**Subject:** Service Bulletin S14XG 8D Battery Cables Routing

**Models Affected:** 2010 through 2015 Model Year All American Front and Rear Engine Models Equipped with Optional 8 D Batteries

## Battery Cable May Contact Battery Compartment Door Reinforcement

Indicates positive cable is contacting compartment door reinforcement

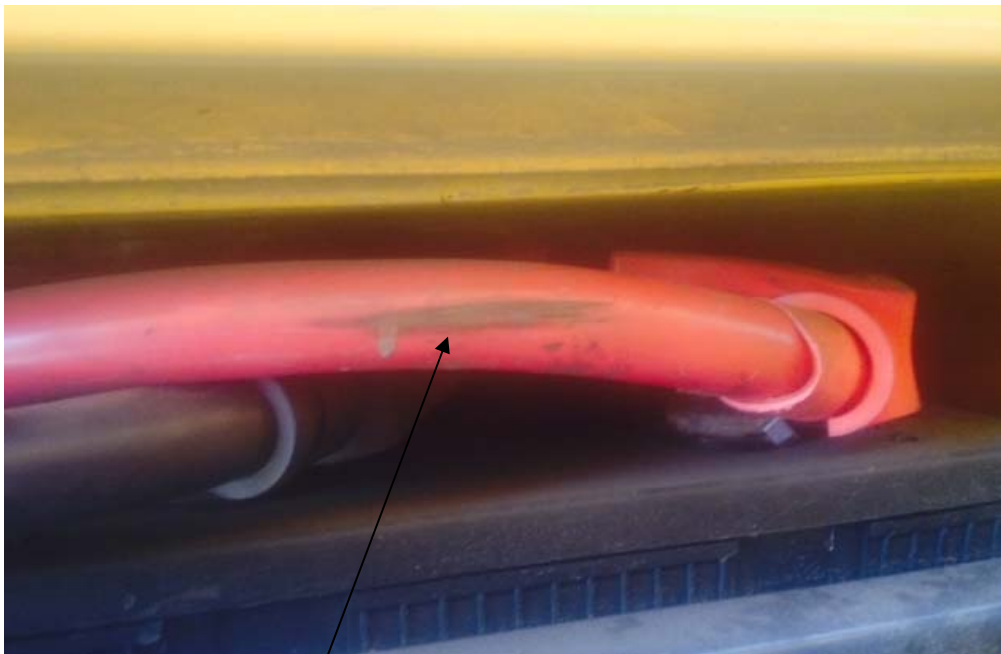
On buses with Feature 40142-04 8 D batteries, the positive battery cable may come in contact with the battery compartment door reinforcement when door is closed.

1. Park the bus on a level surface, apply parking brakes, turn off engine and remove keys. Chock wheels.
2. Open the battery compartment door and inspect the positive battery cable in the battery box for signs of contact with the battery compartment door reinforcement when closed.

Inspect positive cable and, if needed, change routing of battery cables to insure proper clearance. Replace positive battery cable if damaged.

Negative Cable Routed Over Top of Positive Cable

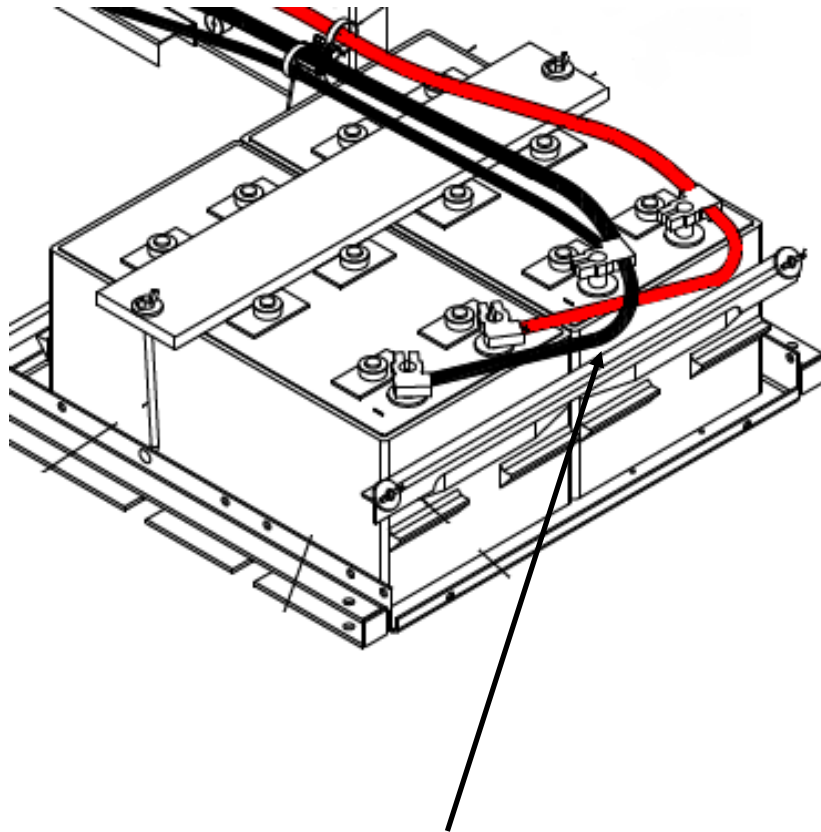
3. If contact is observed, Disconnect batteries – Note: when disconnecting the batteries, remove the negative cable first.
4. Inspect the positive cable for damage.
5. If cable insulation has been damaged to the point that stranded wires are exposed, replace the cable and route per the illustration below.
6. If cable insulation damage is minor and no stranded wire is exposed, route the negative cable so that it is over the positive cable per illustration below.
